80960JA/JF/JD

SPECIFICATION UPDATE

Release Date: July, 1996

Figure C-25. Logical Memory Template Mask Registers (LMMR0-1)

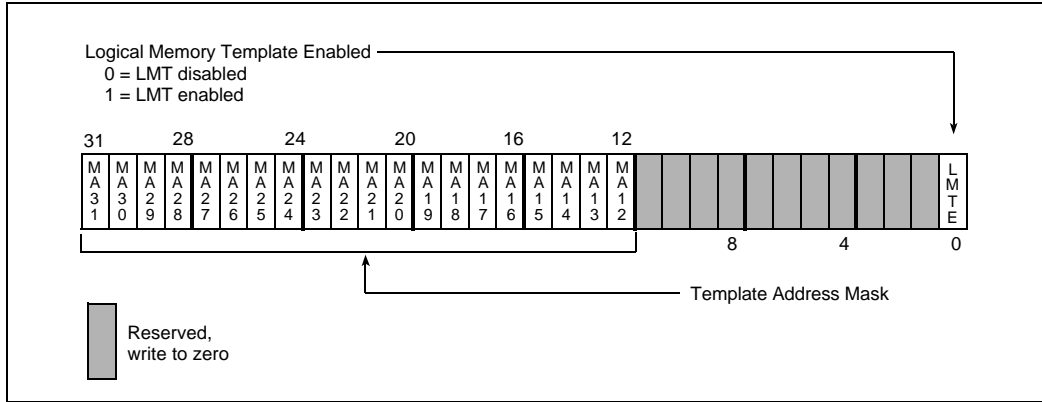
ISSUE: LMMR0-1 Register Diagram is a duplicate of LMADR0-1 register. Figure12-5 (page 12-5) displays the register correctly.

Figure C-25, LMMR0-1 Register Diagram is a duplicate of LMADR0-1 register. Figure 12-5 (page 12-5) displays the register correctly.

Errata 11/14/94 BWL.
